SECTION 00 91 01

ADDENDUM NO. 1

SAN MATEO COUNTY COMMUNITY COLLEGE DISTRICT
CAÑADA/COLLEGE OF SAN MATEO
THEATER HOUSE LIGHTING RETROFIT
CAÑADA COLLEGE - BUILDING 3
4200 FARM HILL BOULEVARD, REDWOOD CITY, CA 94061

E2.1

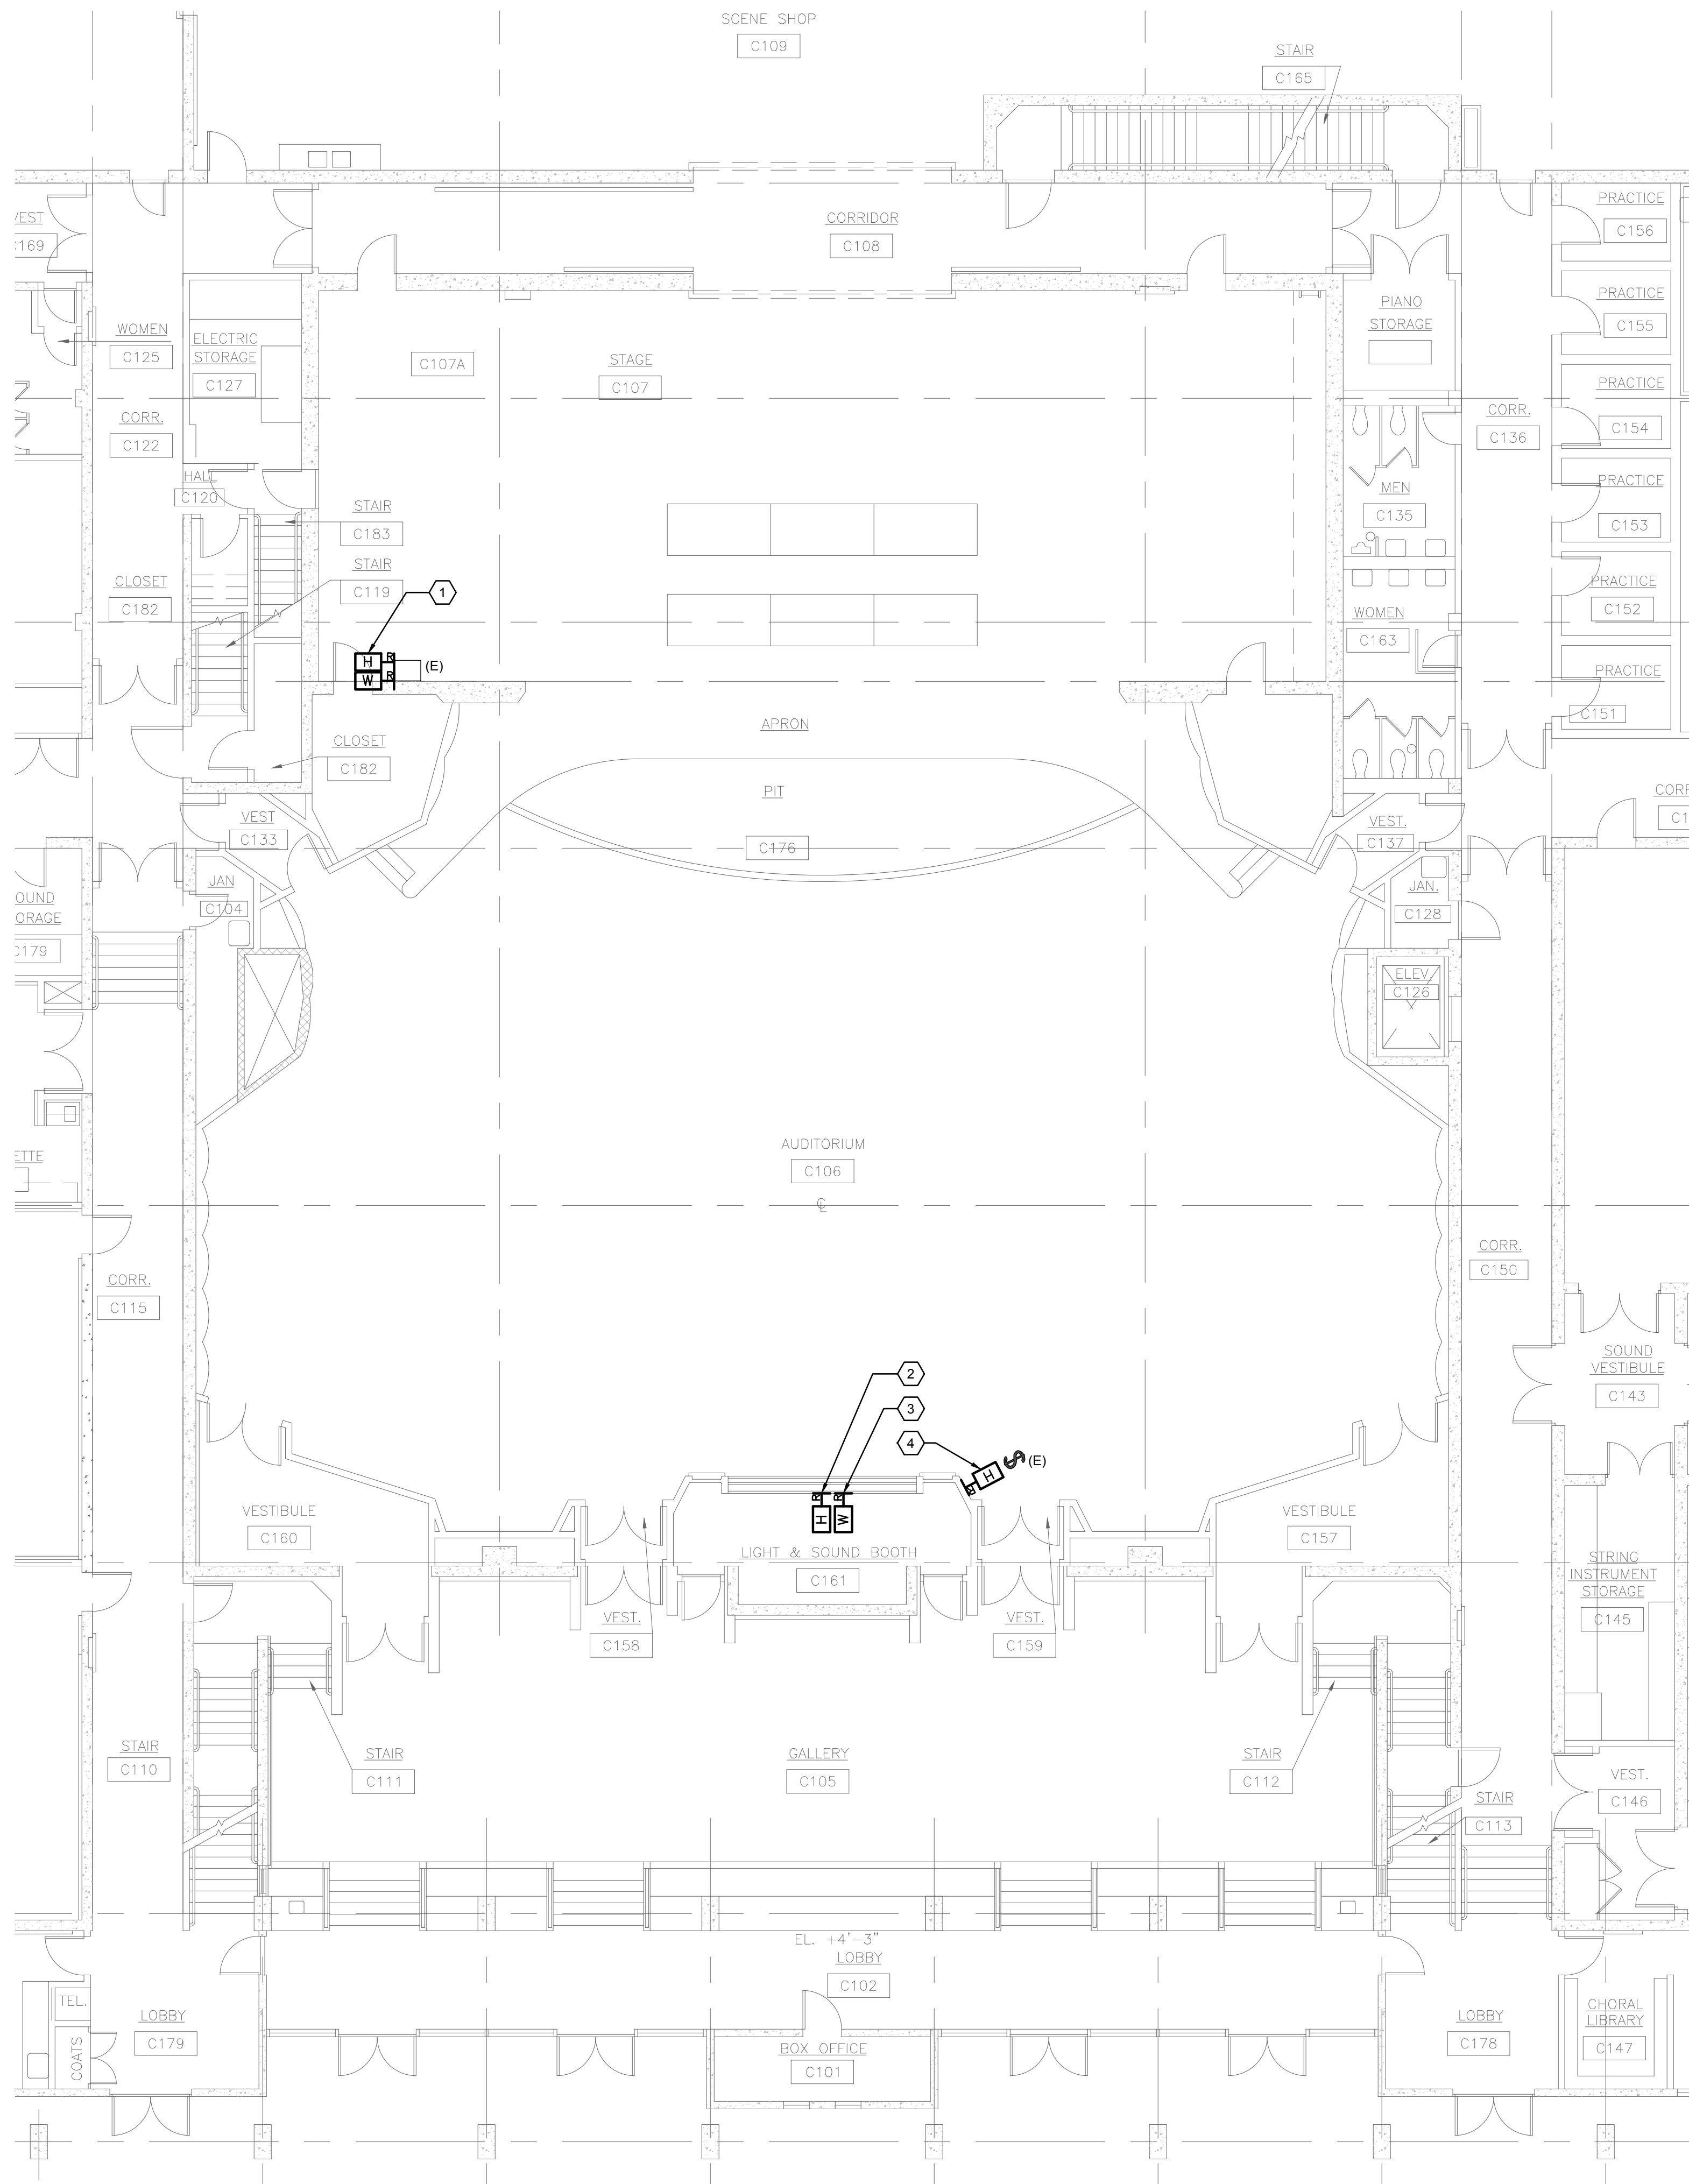
- General Sheet Note "E" was added to sheet E2.1. (See above)
- Sheet E2.1, Sheet Keynote #4 was removed and note #5 & #6 was moved up. Keynote tags also updated in plan.

E2.1

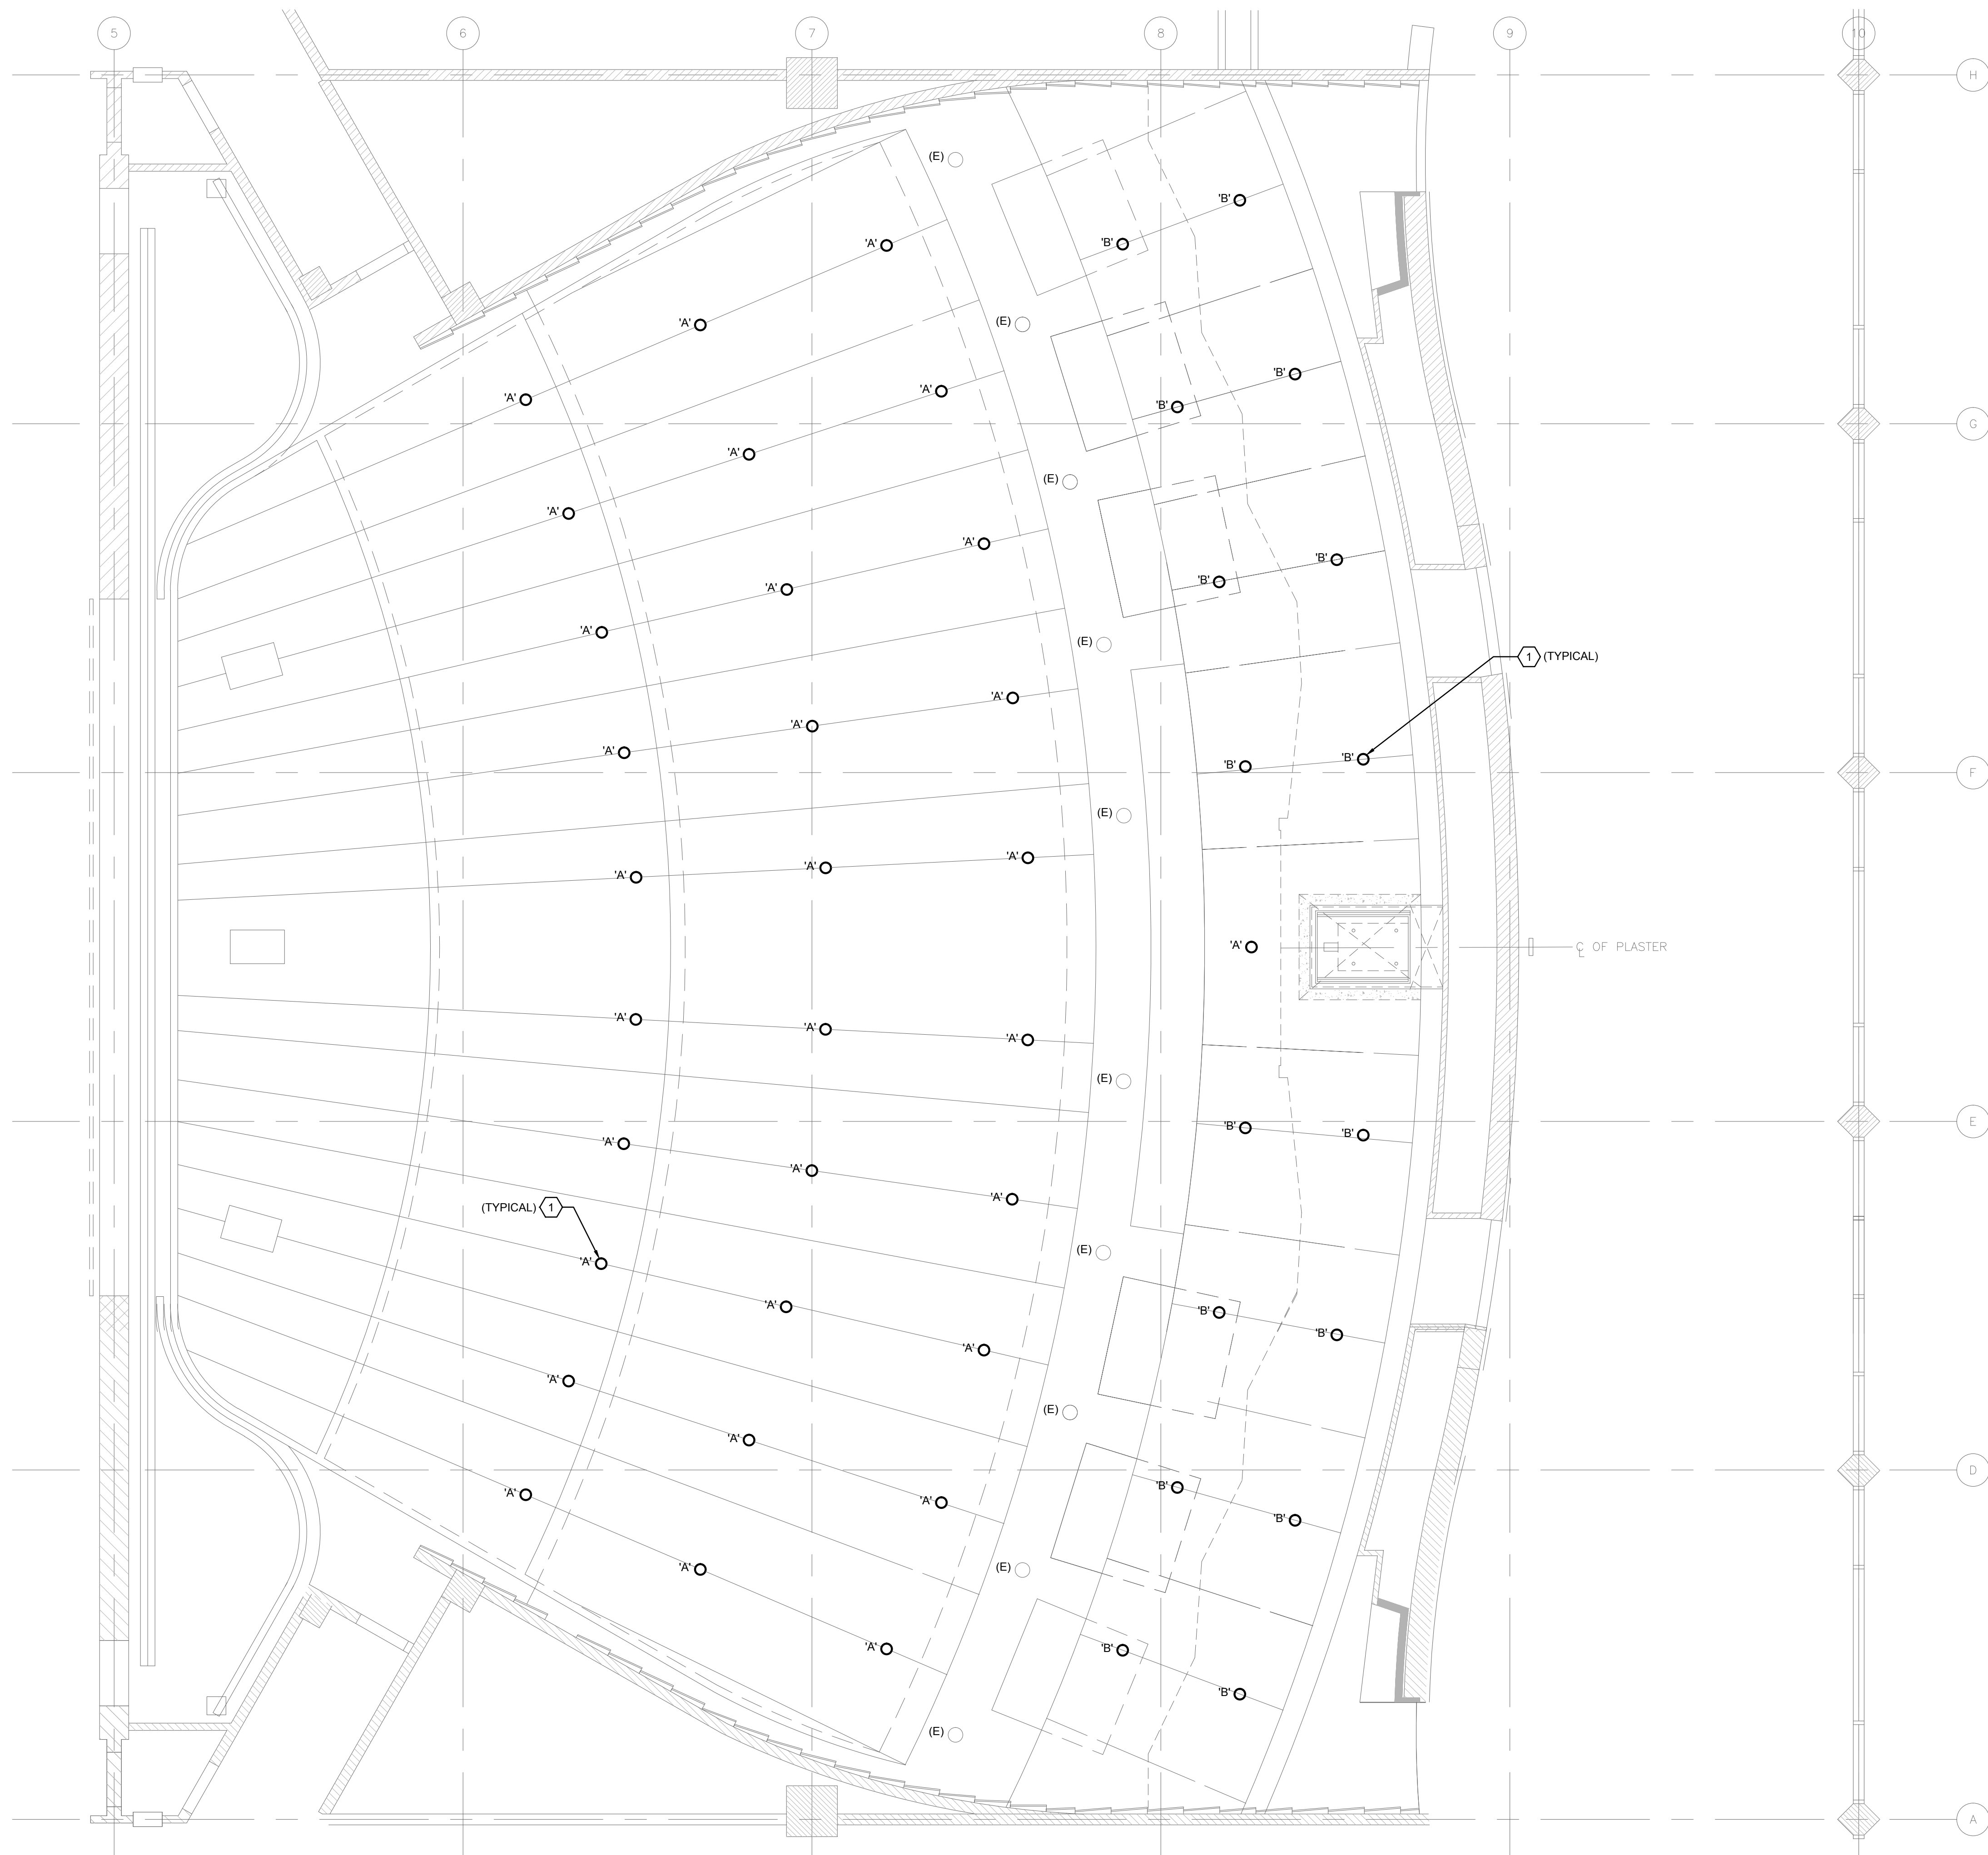
- General Sheet Note "E" was added to sheet E2.1.
